SWP CROSS DRAINAGE EAST BRANCH Mile Post 303.9 to Mile Post 403.4 HYDROLOGIC & HYDRAULIC DATA TABLE B-5

STATE WATER FACILITIES
CALIFORNIA AQUEDUCT
MOJAVE DIVISION

CANAL STA. 1+64.10 TO STA. 955+91.27
STA. "P" 0+00 TO STA. "P" 29+00
TAPERED TRIPLE BOX CULVERT
STA. 151+40 PLAN AND SECTION
DRAINAGE PLAN STA. 143+00 TO STA. 175+00

Riverine Systems near SCH No. 20241000

TRIPLE 6(6-7.5-6) BOX CULVERT
STA. 151+40

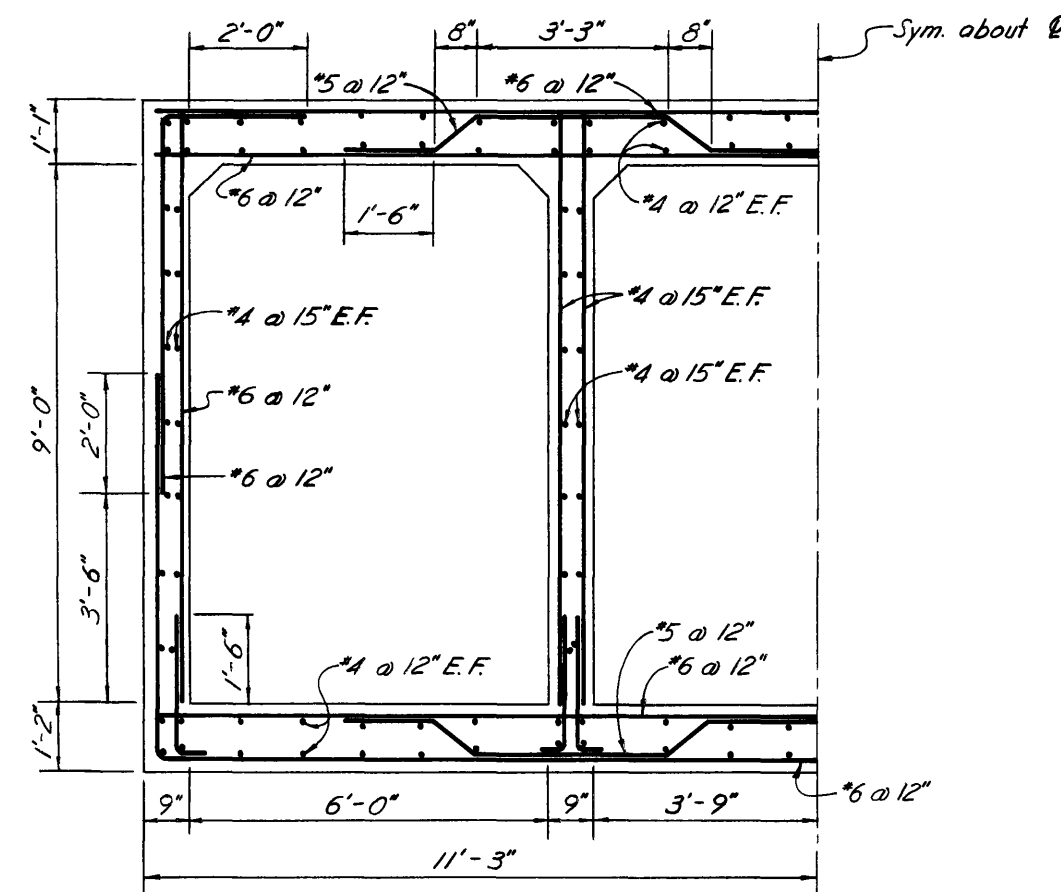
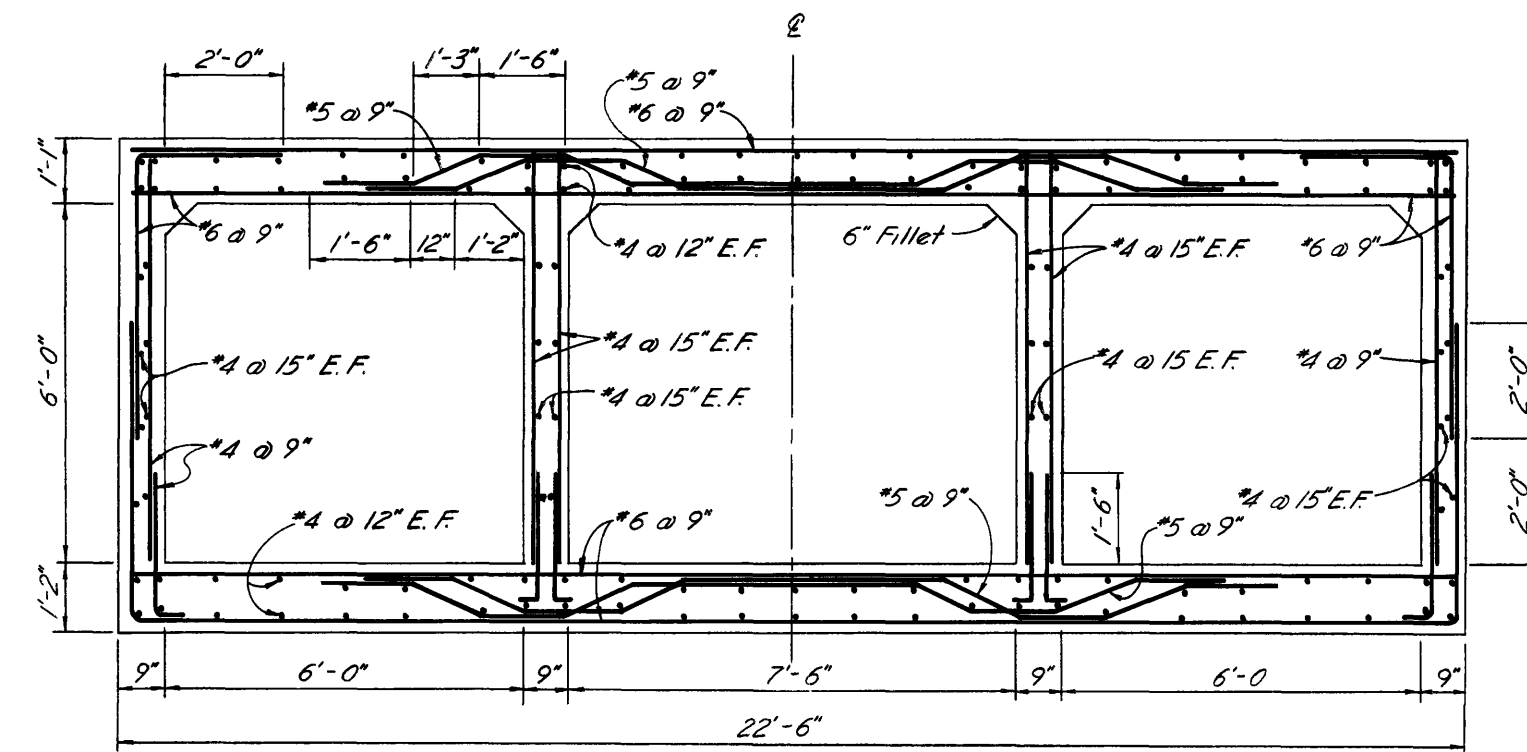
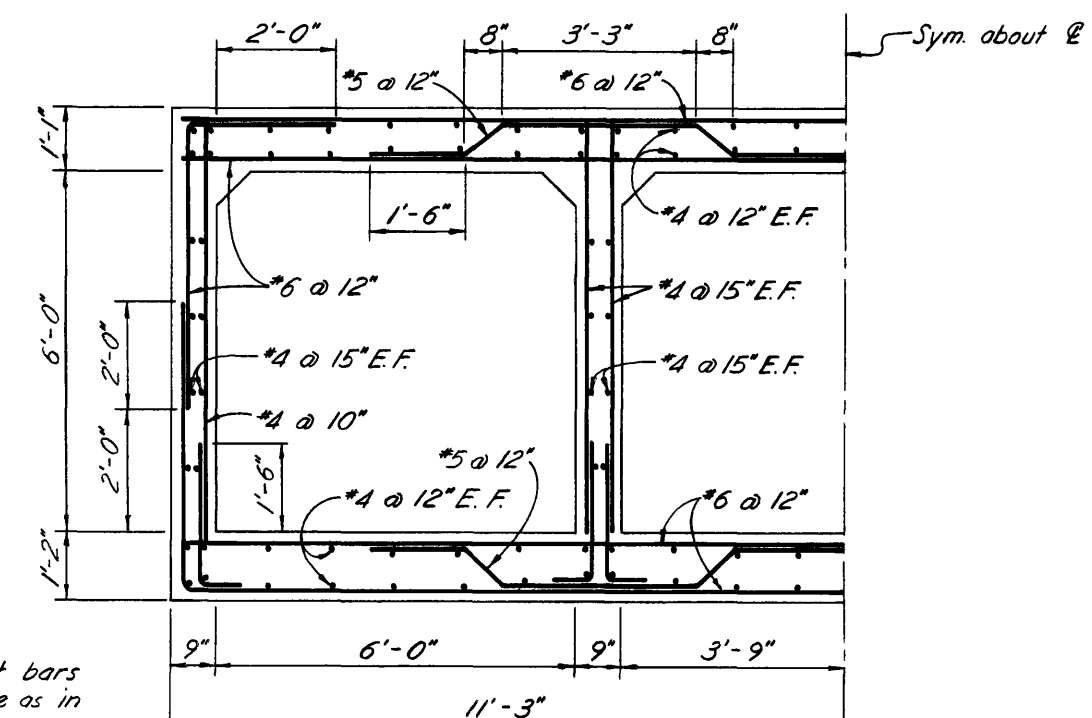
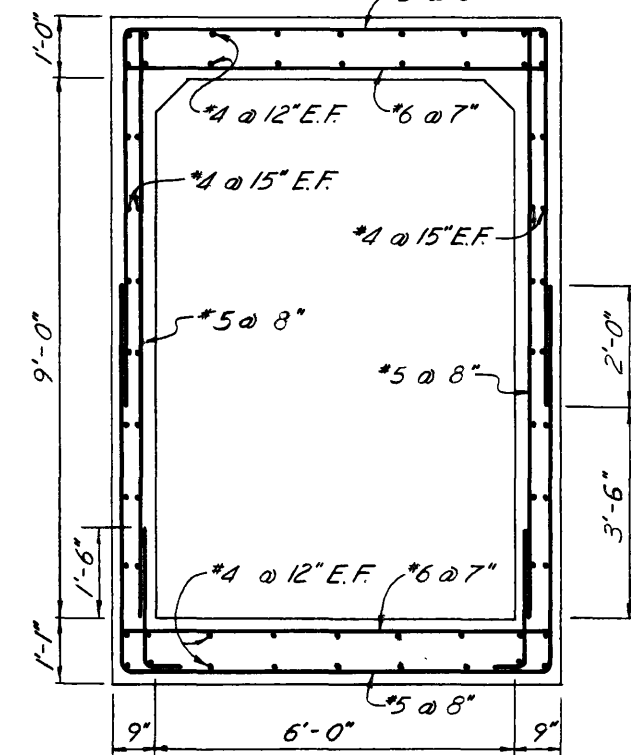
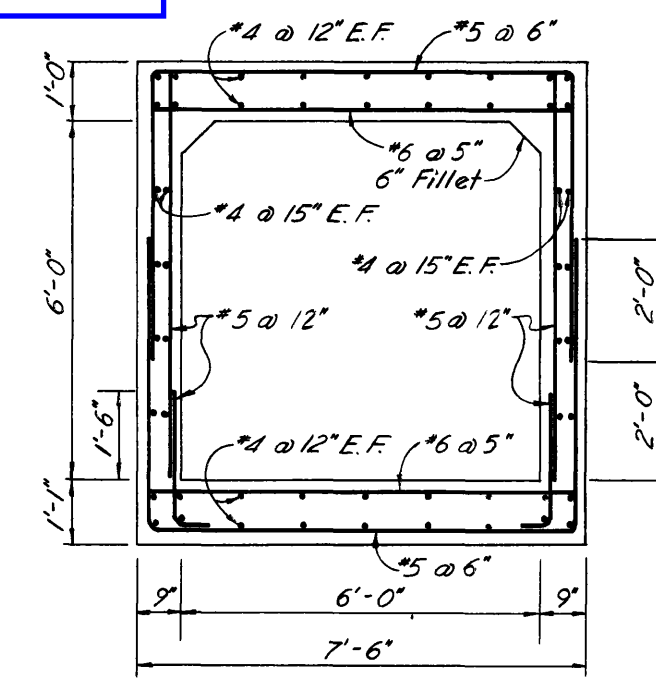
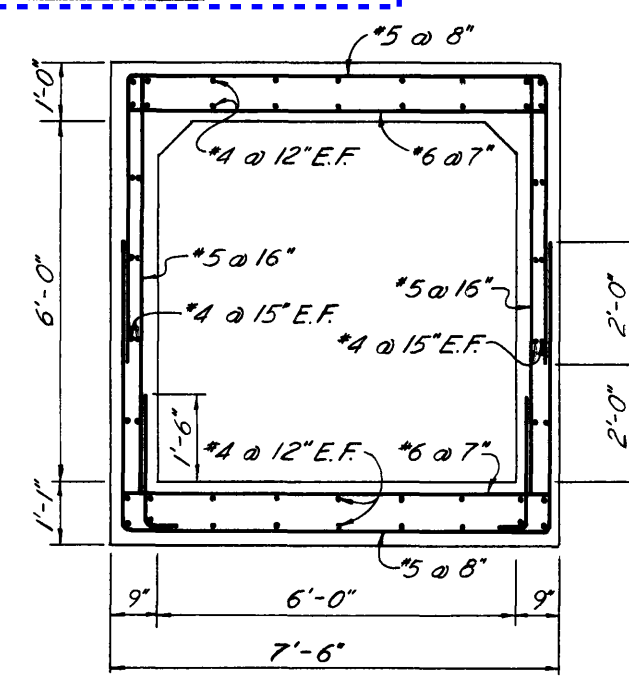
Overflow from
proposed detention
basin in Planning
Area 1 will impact
DWR MP344.8
Structure

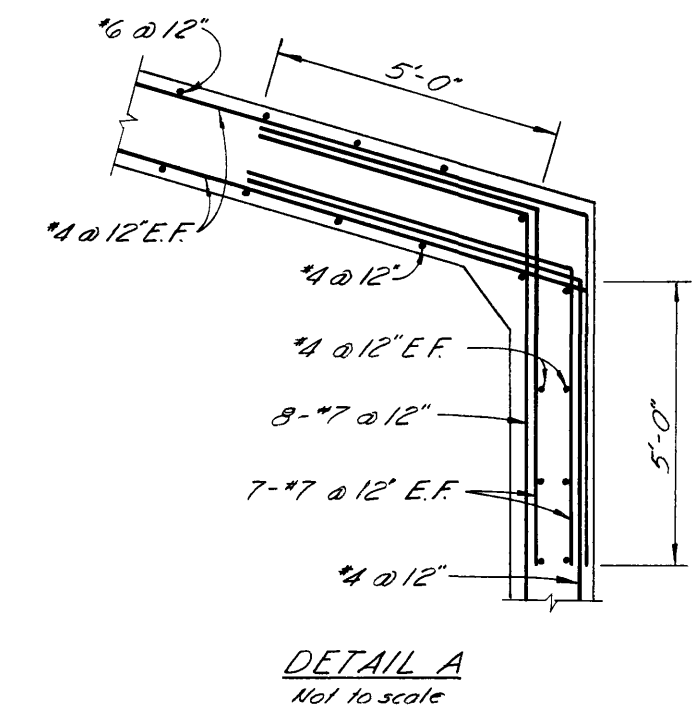
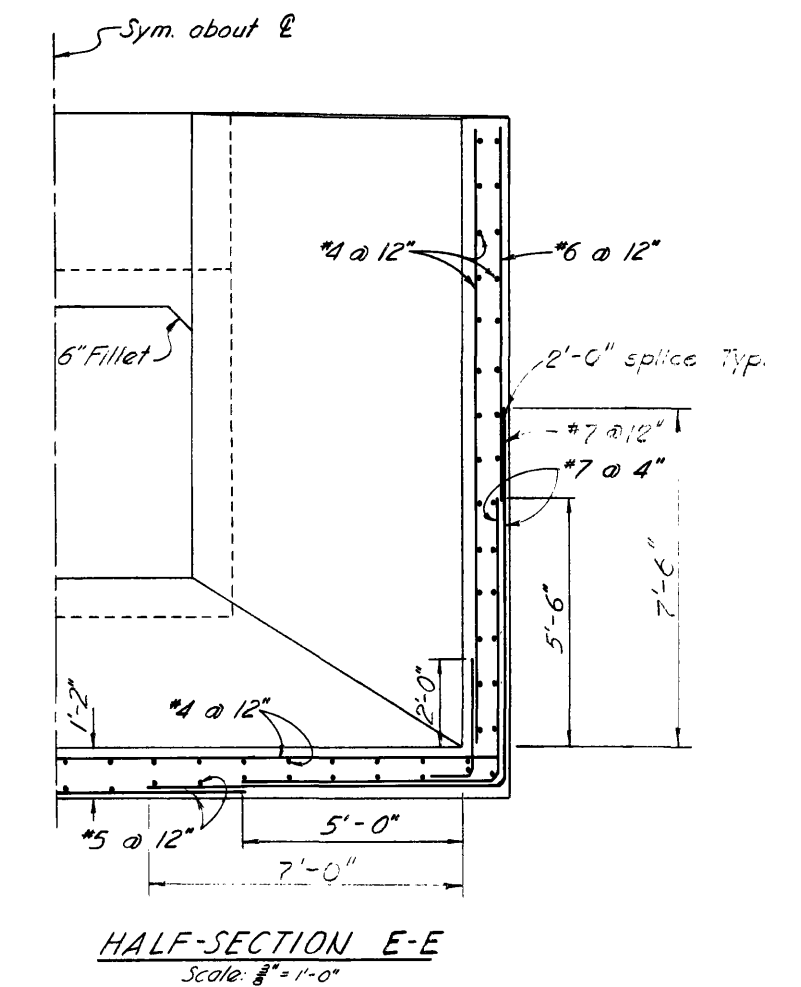
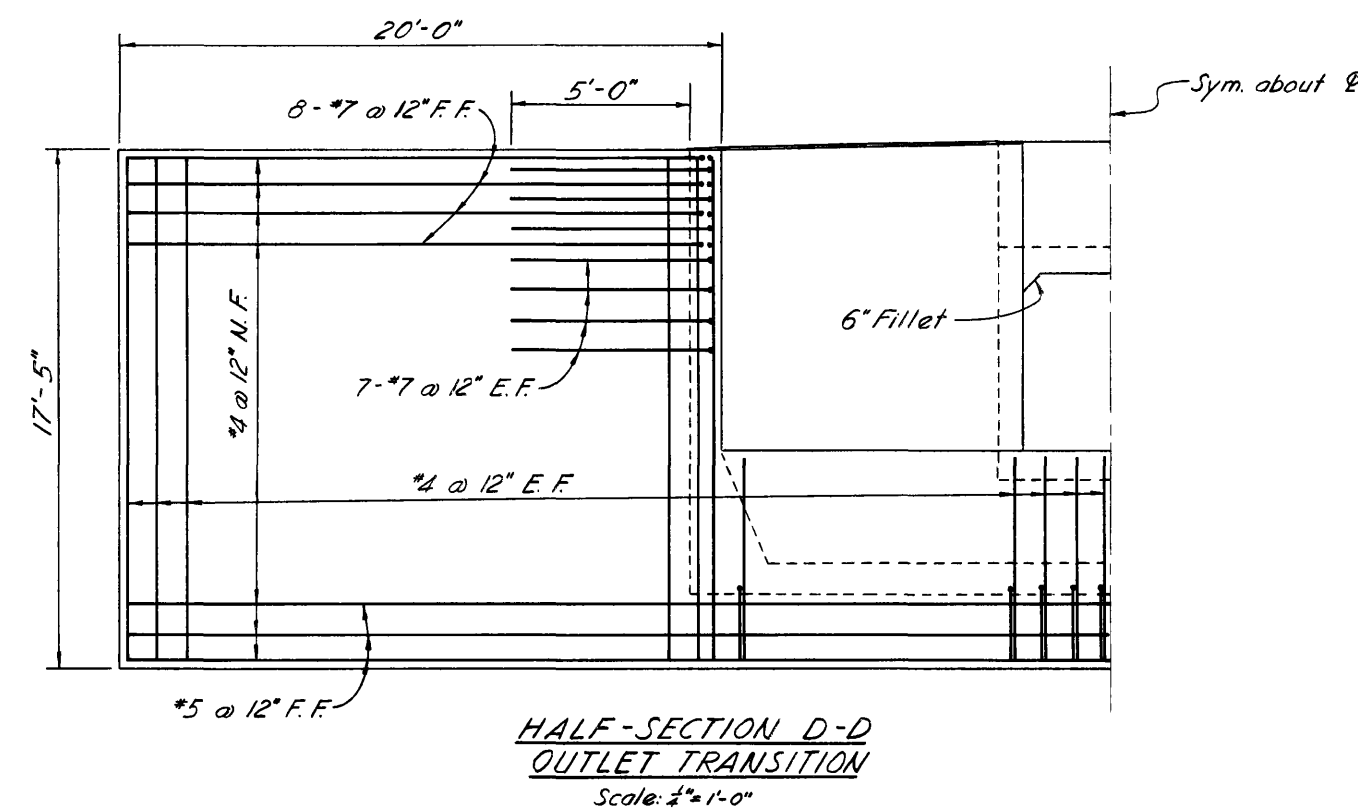
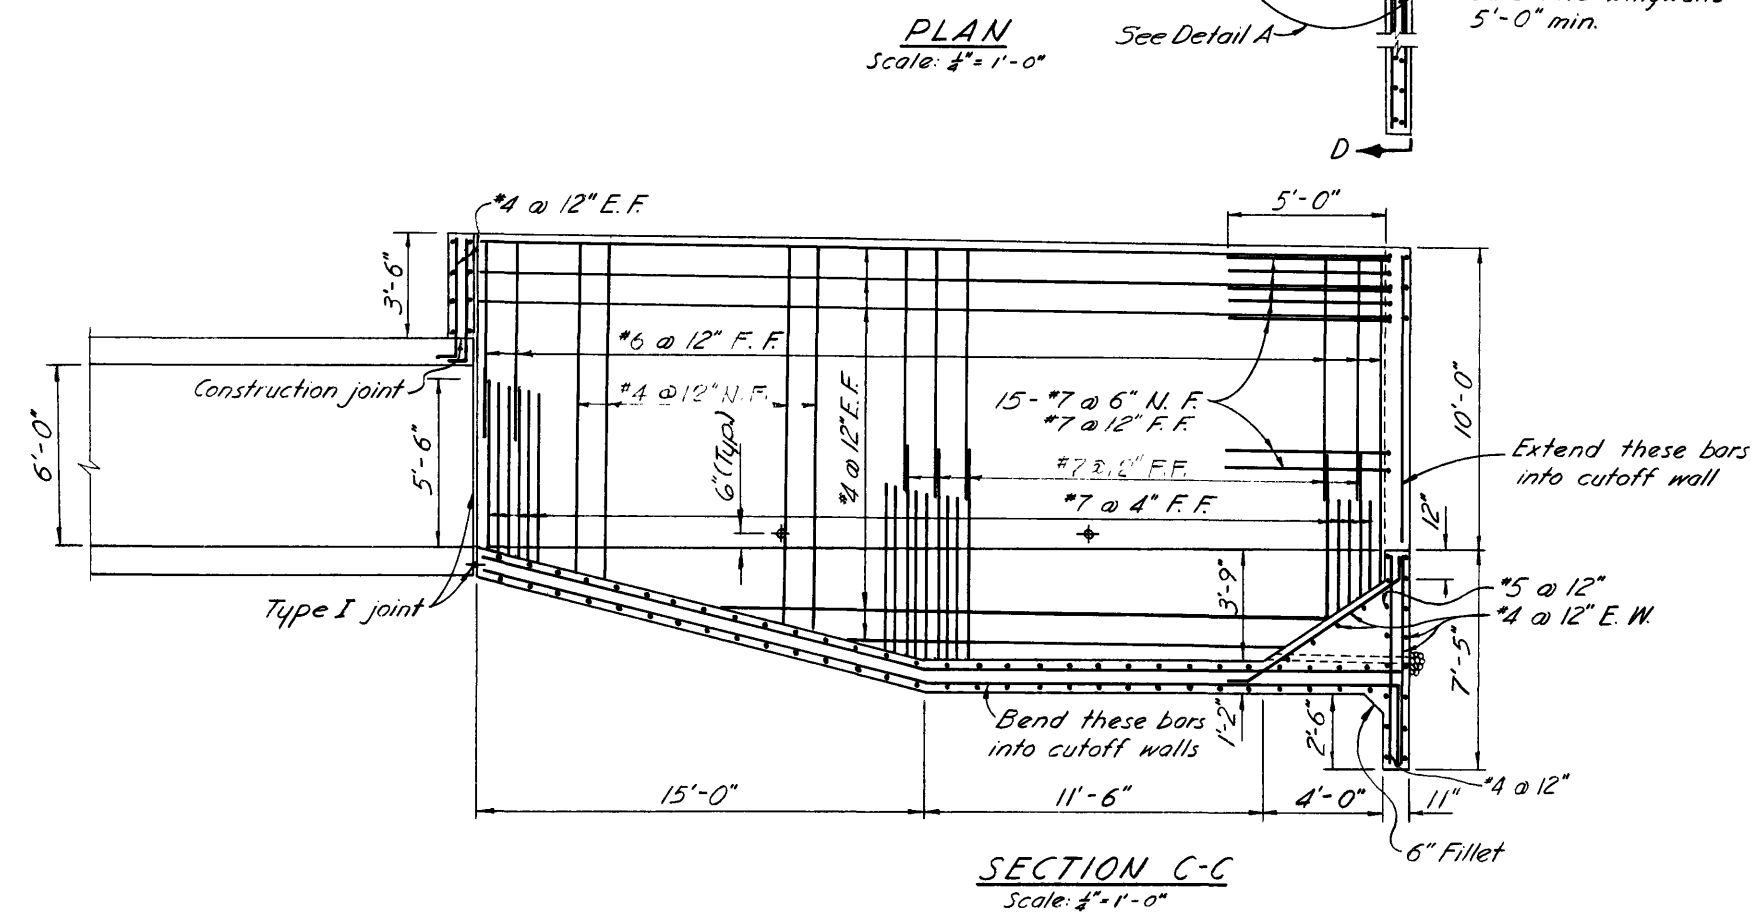
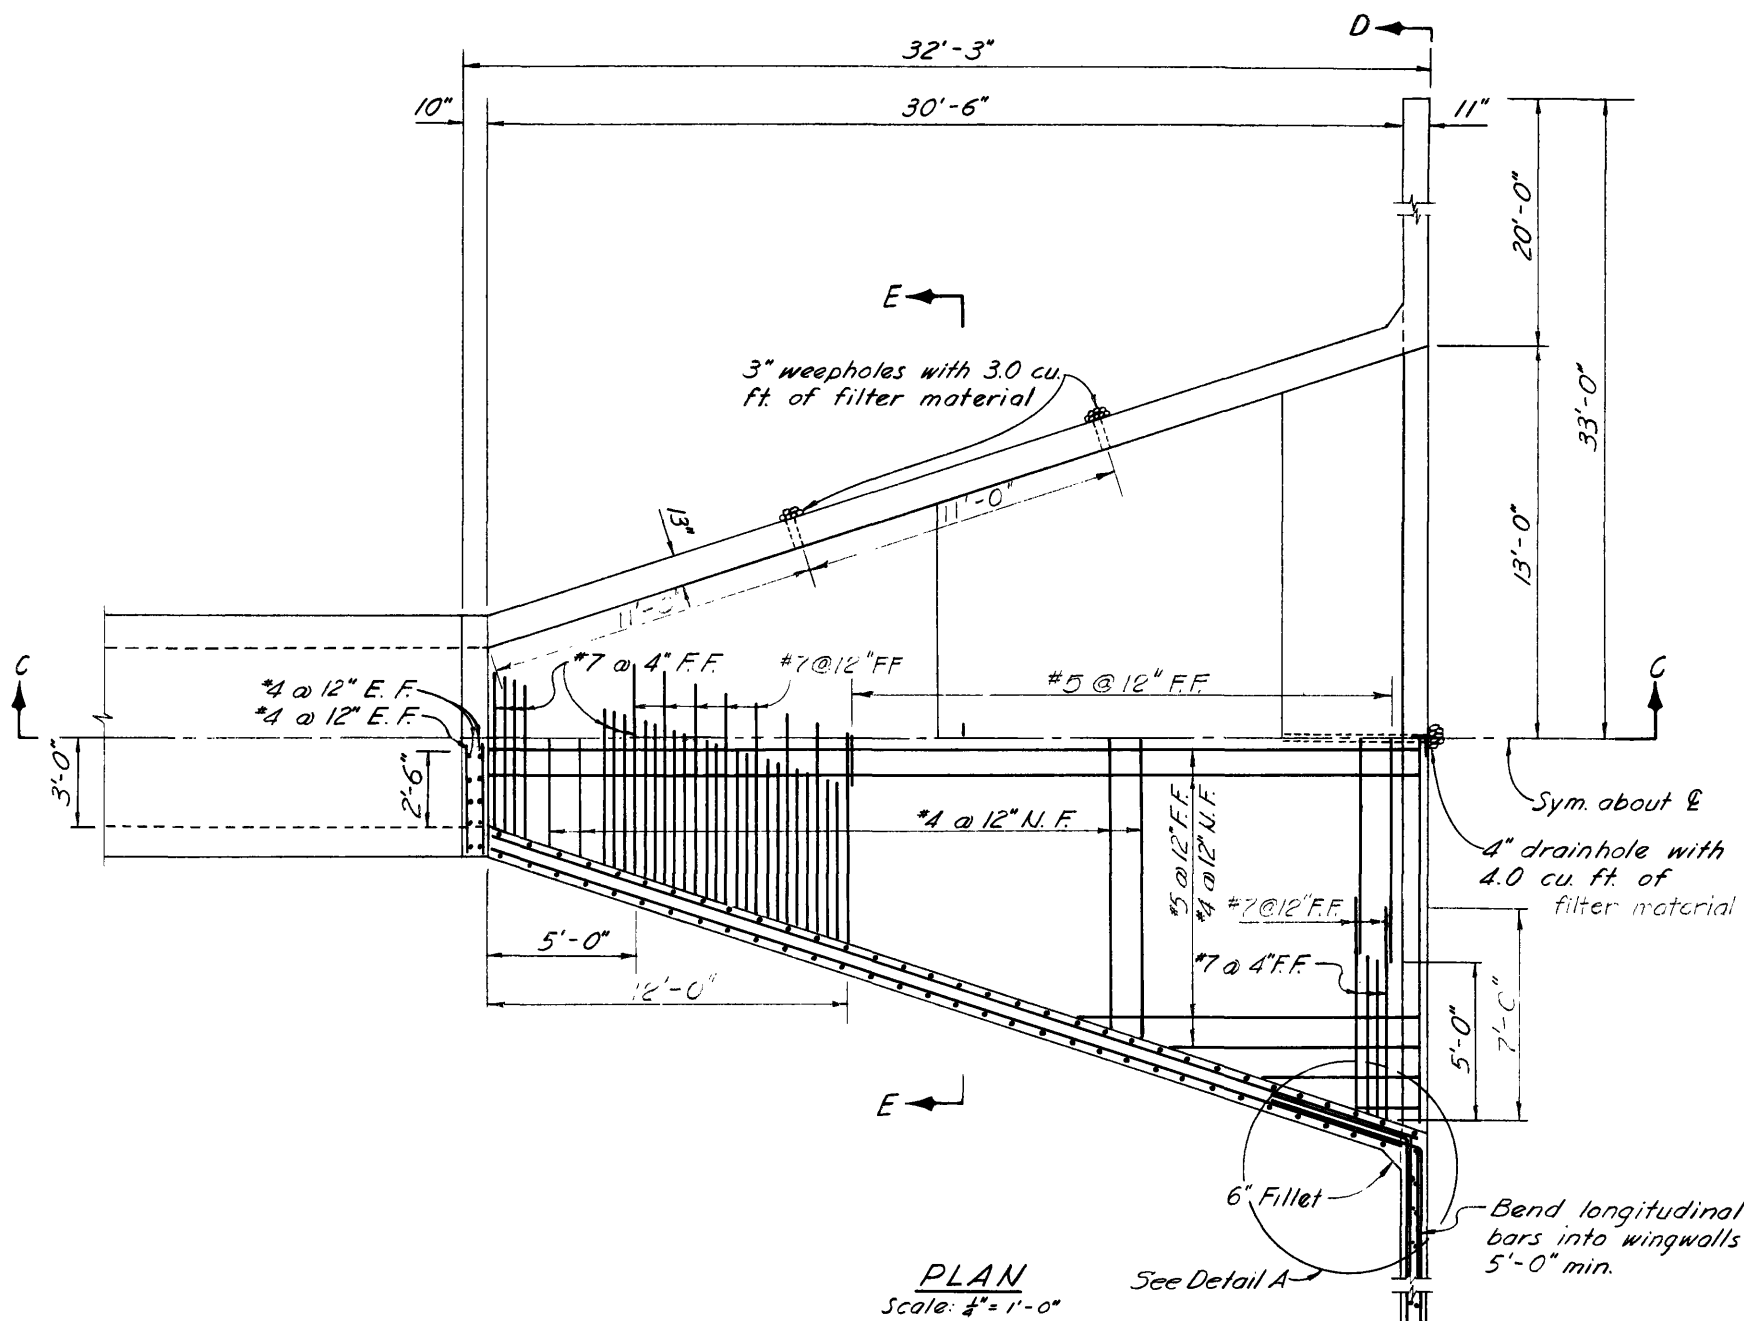
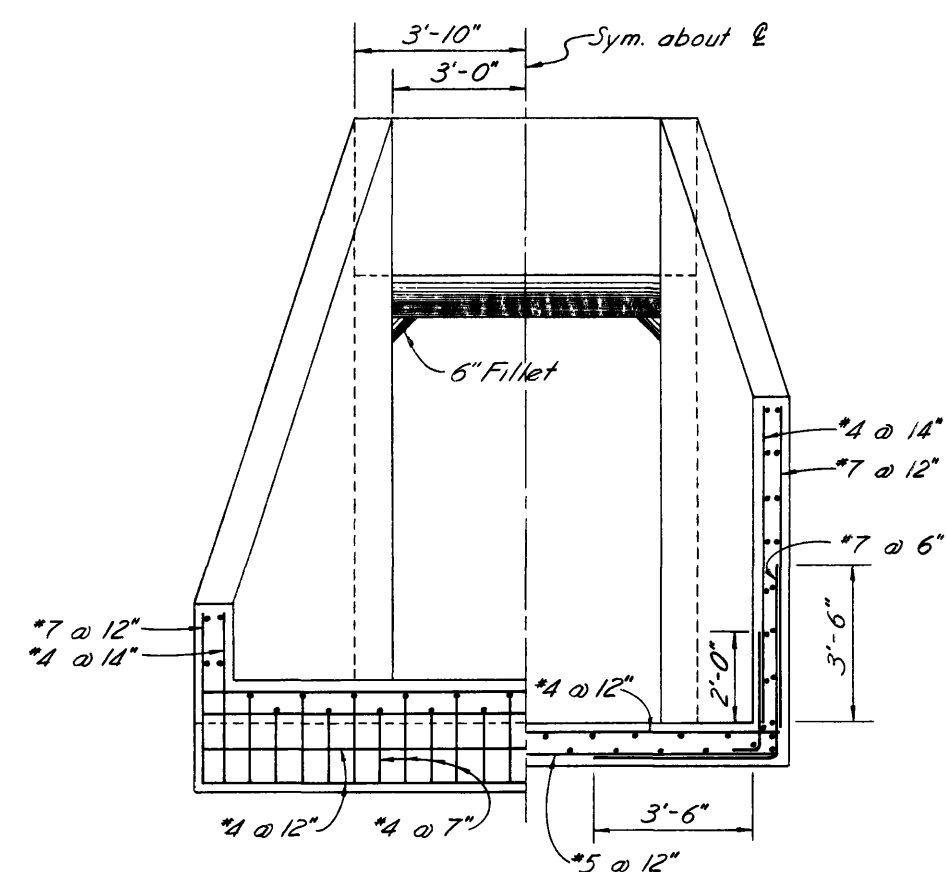
Overflow from proposed
detention basin in Planning
Area 2 will impact DWR MP345.5
Structure
